RE: NARRABRI UNDERGROUND MINE STAGE 3 EXTENSION PROJECT – RESPONSES TO DPIE-WATER SUPPLEMENTARY SUBMISSION

Date 17 September 2021 **Pages** 10
Attention Mark Vile
Company Narrabri Coal Operations Pty Ltd
Job No. 0189-13-L1
Subject Narrabri Underground Mine Stage 3 Extension Project (SSD-10269)
Response to DPIE and NRAR Information request

RE: Narrabri Stage 3 Extension Project Groundwater Assessment Response to DPIE Water Supplementary Submission dated 11 August 2021

Figure 1 - Narrabri Stage 3 layout and drainage characteristics

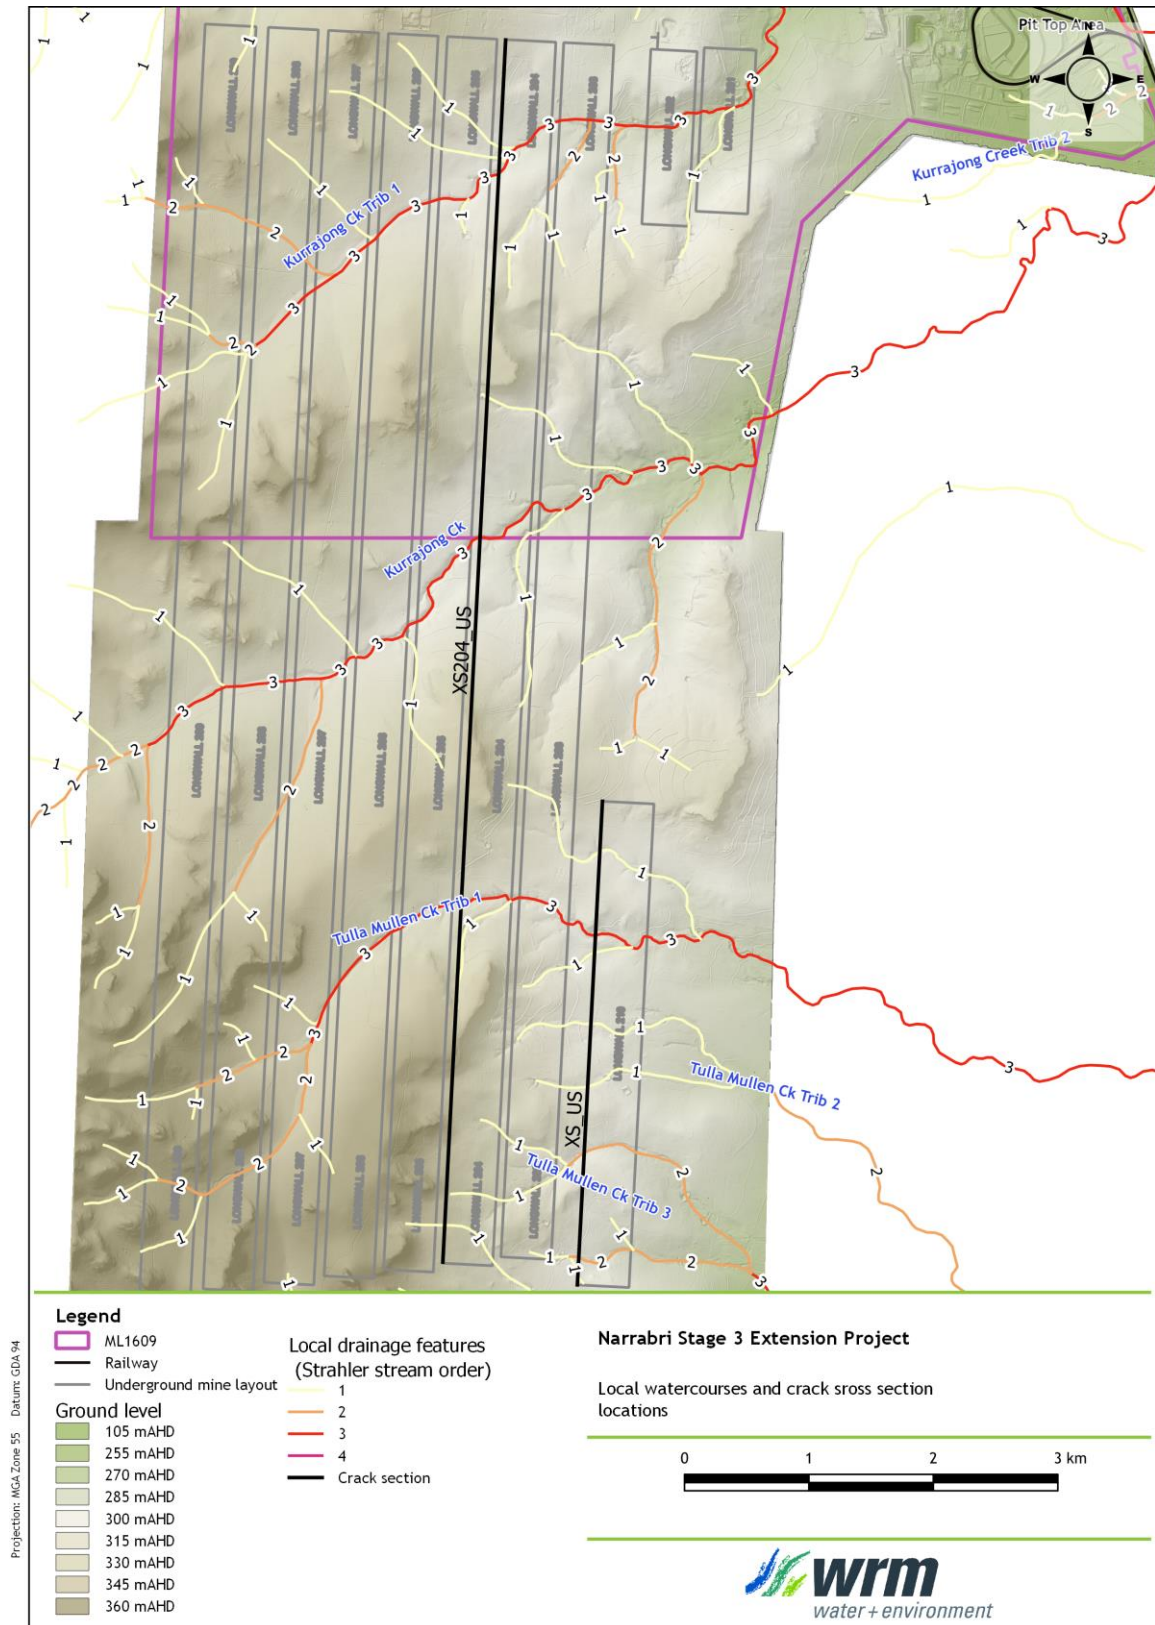
Quantify the annual volume of surface water take due to subsidence related surface fracturing for both the existing and proposed project for a range of climatic scenarios (wet, average, dry) and demonstrate sufficient entitlement can be acquired in the relevant water source to account for the maximum take.

DGS provided a spreadsheet of the expected crack volumes around each Stage 3 longwall panel (LW203 to LW210) (see Figure 1). Volumes were provided for the maximum period between crack repair, which was advised by NCOPL to be six months. A copy of the DGS spreadsheet is given in Table 1.

Figure 1 shows the Project area and the watercourses which traverse the area. Stream order for these watercourses is also shown.

Figure 2.1 Water balance time series January 2009 to June 2019

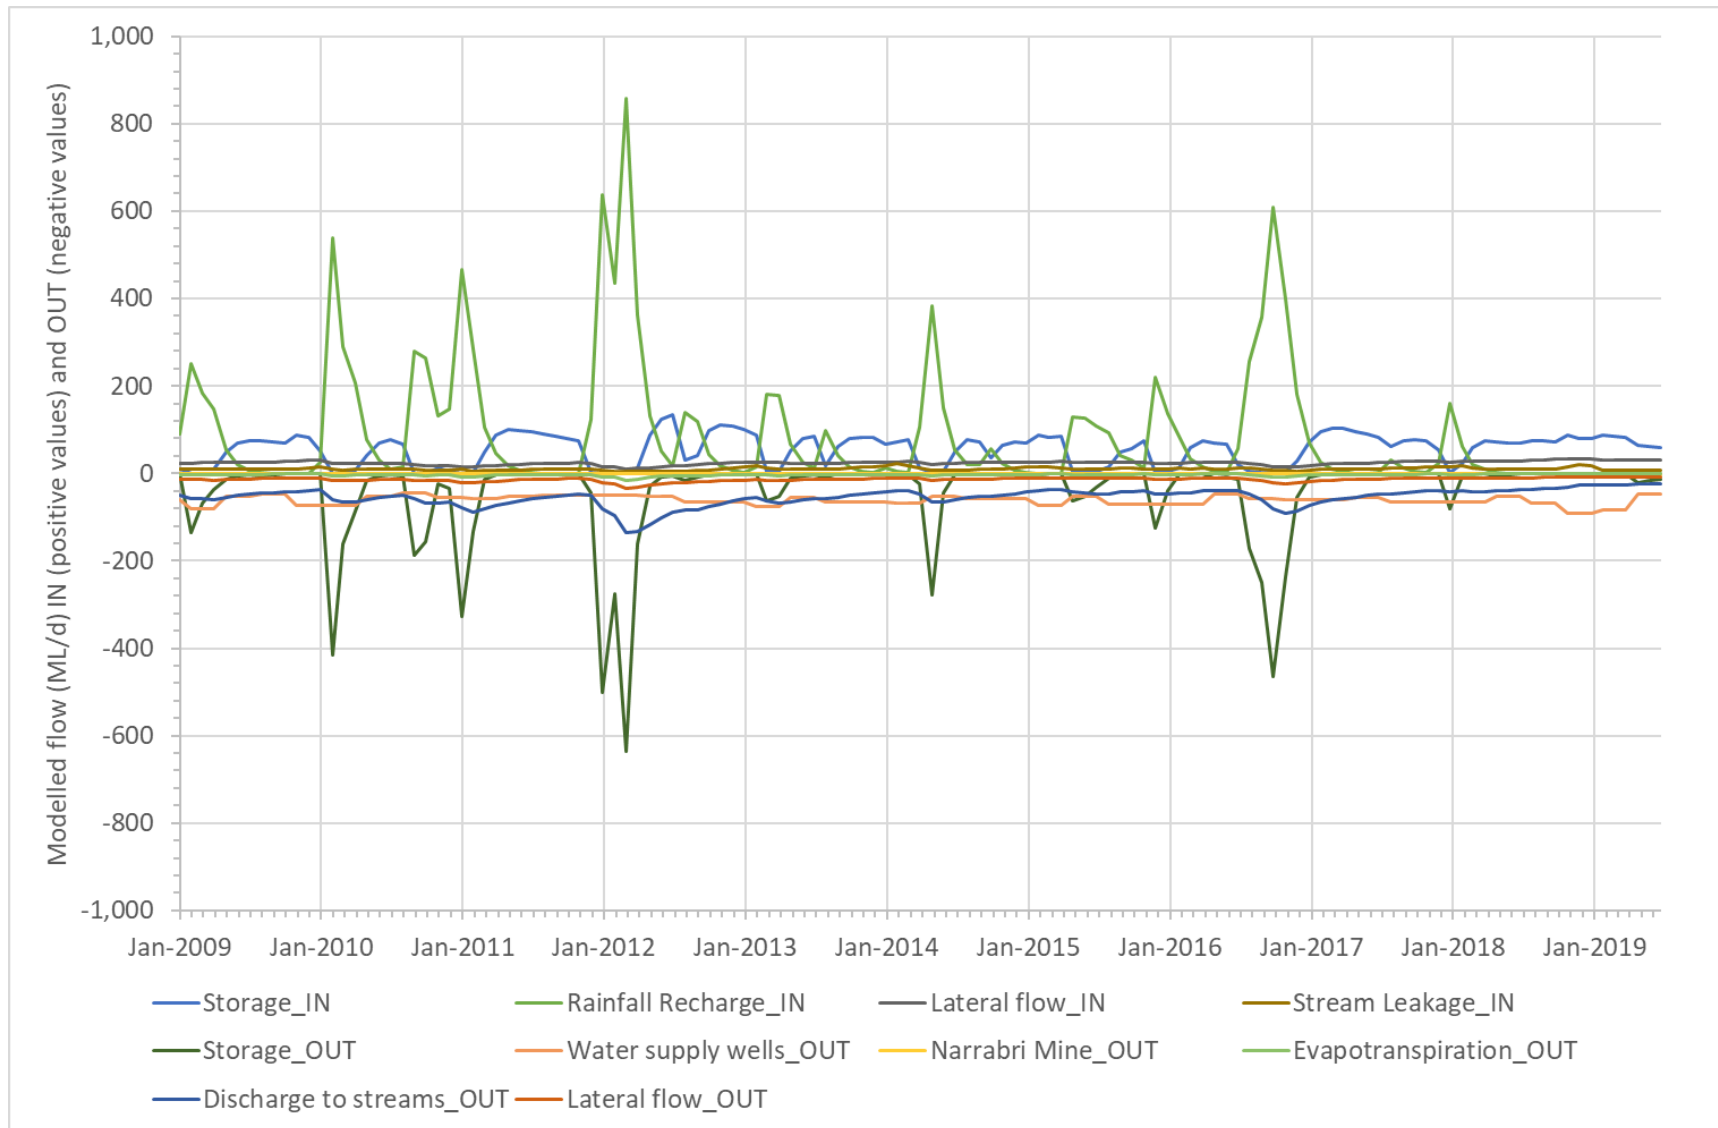
The terminology and expression applied in the presentation of the modelled water balance results, especially regarding groundwater storage, are ambiguous and require clarification. The proponent describes storage inputs which the readers might assume to refer to increased storage water in the aquifer, but alternatively might mean water release from storage. Accordingly, the water balance as presented cannot be verified against rainfall conditions.

Clarify the modelled water balance by defining the storage and recharge components, their relationship with each other, and the notation used to present their relative changes, so that their predicted inflows and outflows are not ambiguous.

Appendix D of the Narrabri Underground Mine Stage 3 Extension Project Groundwater Assessment Report (Australasian Groundwater and Environmental Consultants Pty Ltd [AGE], 2020, referred to hereafter as the GA Report)¹ includes the following table (Table D 3.11 reproduced here as Table 1) which summarises inflows and outflows to the MODFLOW groundwater flow modelling tool developed for the assessment. As shown in Table 1 results are presented for a steady state calculation, which relates to the pre-mining period, and averages for the transient calibration period which runs from January 2009 to June 2019. Time series of each water balance component summarised in Table 1 are also shown in Figure 2.1.

When interpreting the time series chart and table it is important to note that the MODFLOW modelled Storage IN water balance term represents water that is being released from storage and hence represents an inflow to the model. As shown in Figure 2.1, Storage IN therefore increases during dry periods when rainfall recharge is zero and releases from storage to essentially support ongoing outflows from the model (i.e. baseflow to rivers and groundwater extraction from Narrabri Mine and water supply wells). This leads to declining groundwater levels in the simulation as the amount of water held in storage reduces.

Conversely the modelled Storage OUT water balance term represents water that is entering storage and hence is effectively leaving the simulation (albeit temporarily) and entering the groundwater store. As shown in Figure 2.1 Storage OUT therefore increases during wet periods when rainfall recharge is relatively high and excess water, over and above the other ongoing water demands, enters storage. This in turn leads to increasing groundwater levels in the simulation as the amount of water held in storage increases.

As summarised in Table 1 over the modelled calibration period from January 2009 to June 2019 the average of the storage IN values (57.8 ML/day) exceeds the average of the storage OUT values (49.9 ML/day) (i.e. the volume of water being released from storage and entering the simulation slightly exceeds the volume of water leaving the simulation entering storage). This is consistent with the lower than average rainfall conditions which have prevailed for much of the calibration period, particularly in the period since early 2012. Hence, as shown in Figure 2.1 the periods in which modelled recharge is occurring and water is entering storage (i.e. storage_OUT is also elevated) are separated by long periods when water being released from storage (i.e. storage_IN is elevated) to support ongoing outflows (predominantly extraction from water supply wells and discharge to surface water courses).
